Review Comments and Request for Additional Information

Woman's Leadership Center

Village of Williams Bay

October 2, 2023

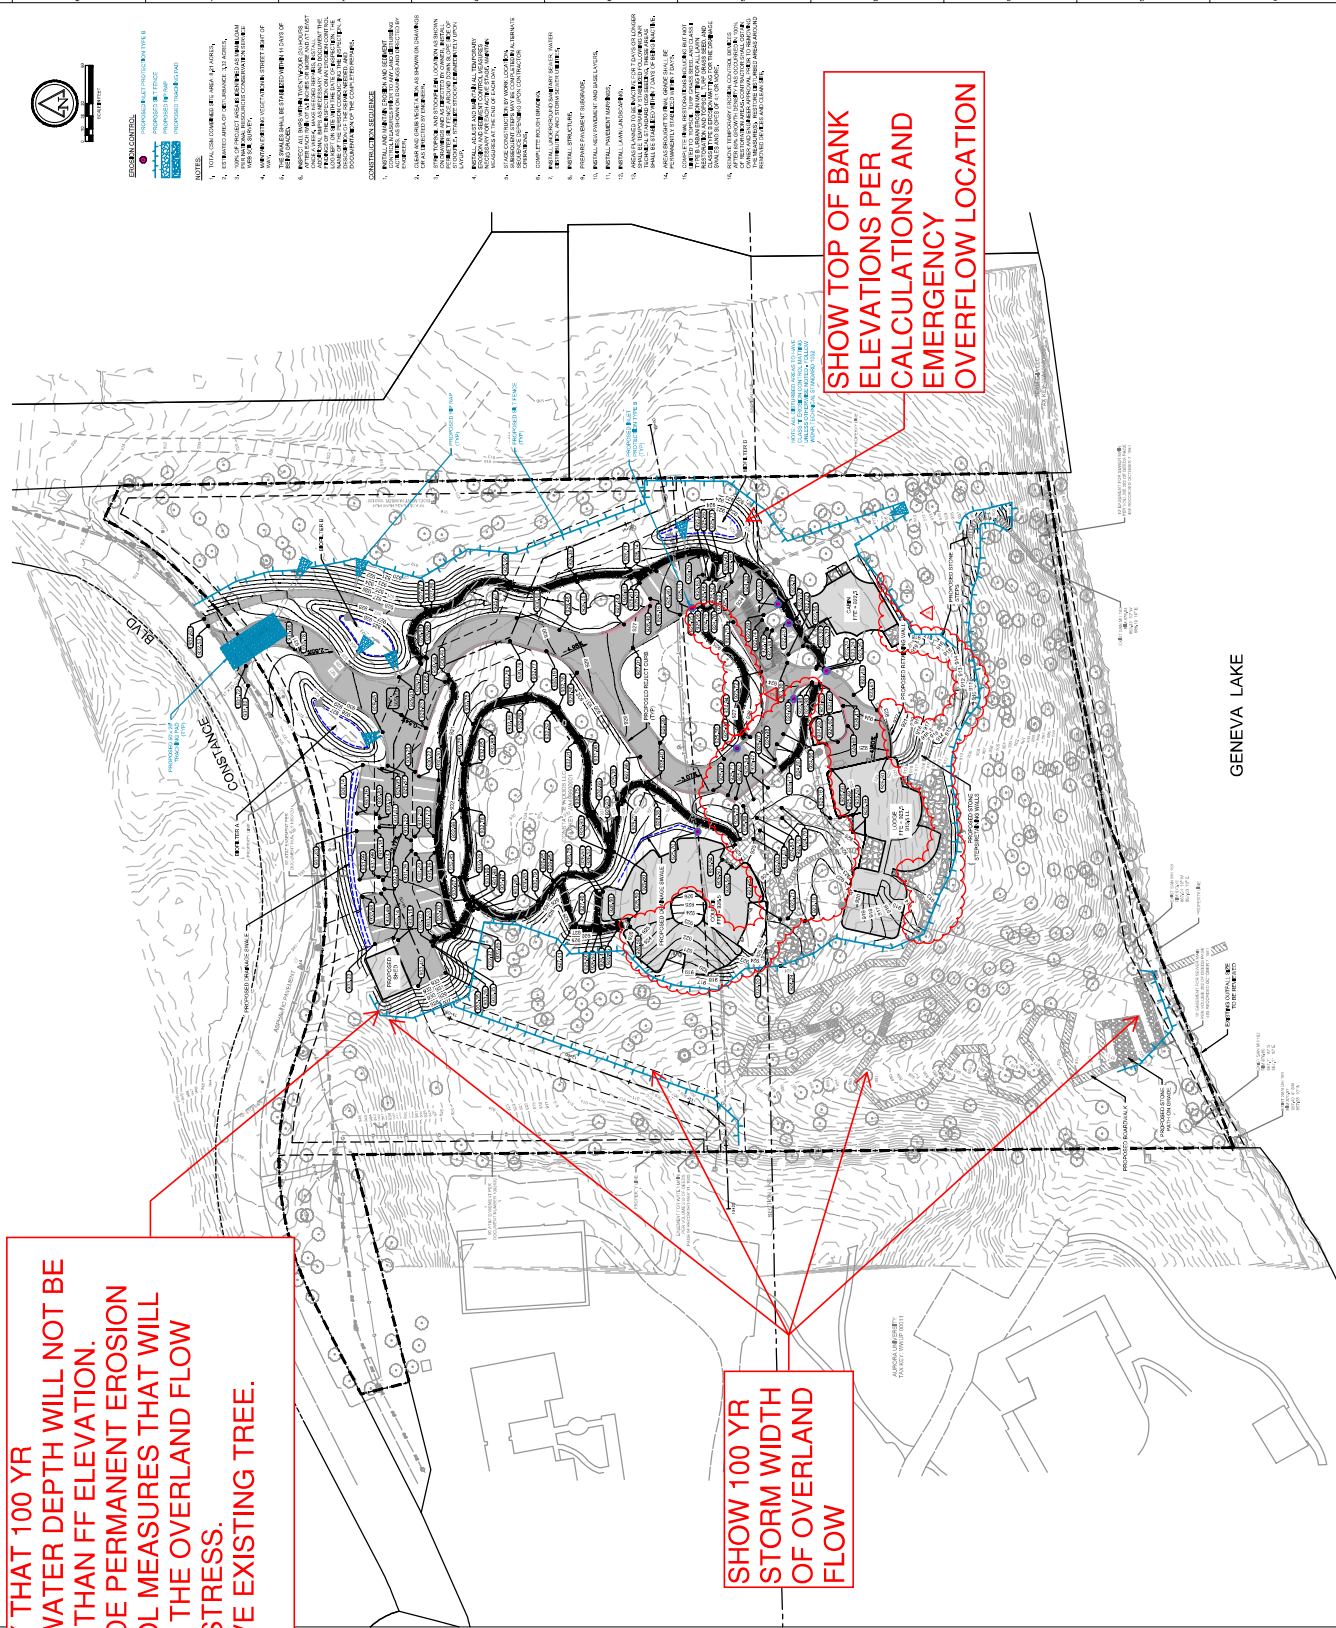
2. Sheet C-500 (Grading & Erosion Control Plan):
 - a. Provide biofilter emergency overflow locations and erosion control measures.
 - b. The proposed shed and boardwalk are blocking an existing drainage path.

- VERIFY THAT 100 YR STORMWATER DEPTH WILL NOT BE HIGHER THAN FF ELEVATION.
- PROVIDE PERMANENT EROSION CONTROL MEASURES THAT WILL HANDLE THE OVERLAND FLOW SHEAR STRESS.
- REMOVE EXISTING TREE.

SHOW TOP OF BANK
ELEVATIONS PER
CALCULATIONS AND
EMERGENCY
OVERFLOW LOCATION

C-701

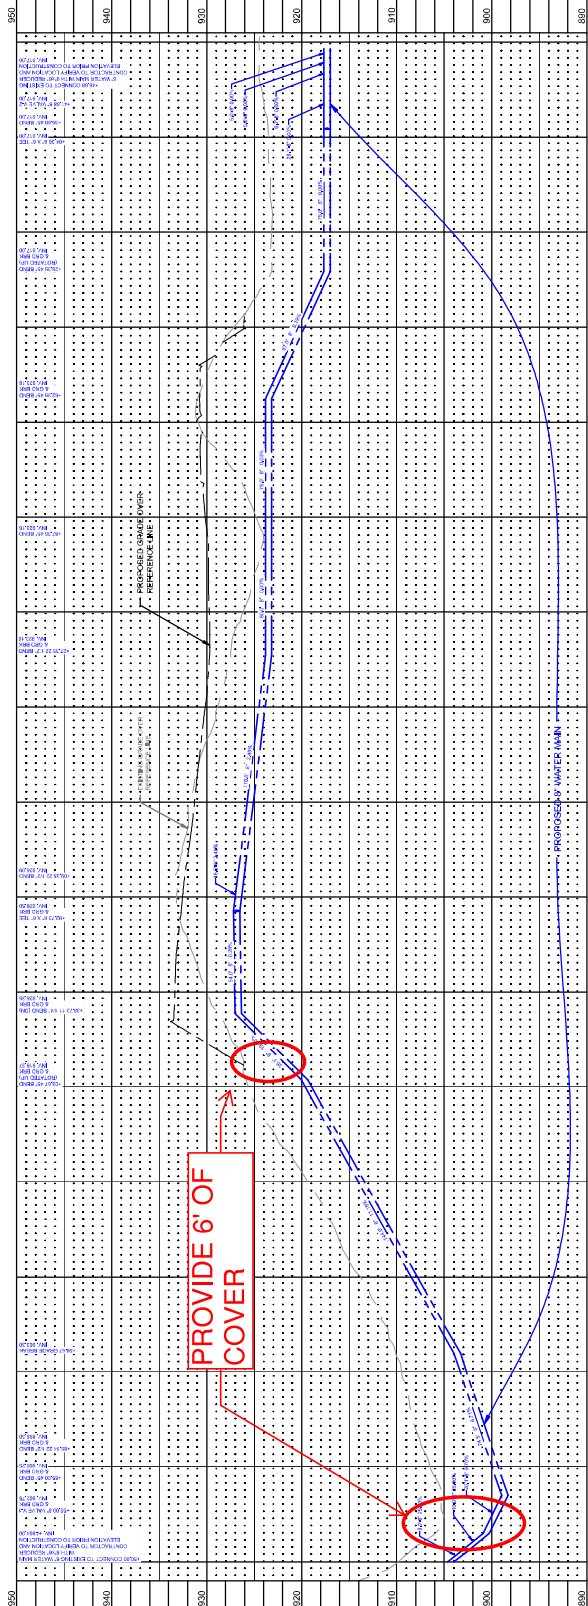
- e. The three biofilter invert elevations do not match the Hydrocad calculations.
4. Sheet C-701 (Proposed Water Main Profile):
 - a. Provide 6-ft of water main cover, see marked up plan sheet.

- b. Show areas requiring granular trench backfill under proposed pavement.
5. Sheet C-800 (Construction Details):
 - a. The outlet control structure details do not match the Hydrocad calculations.
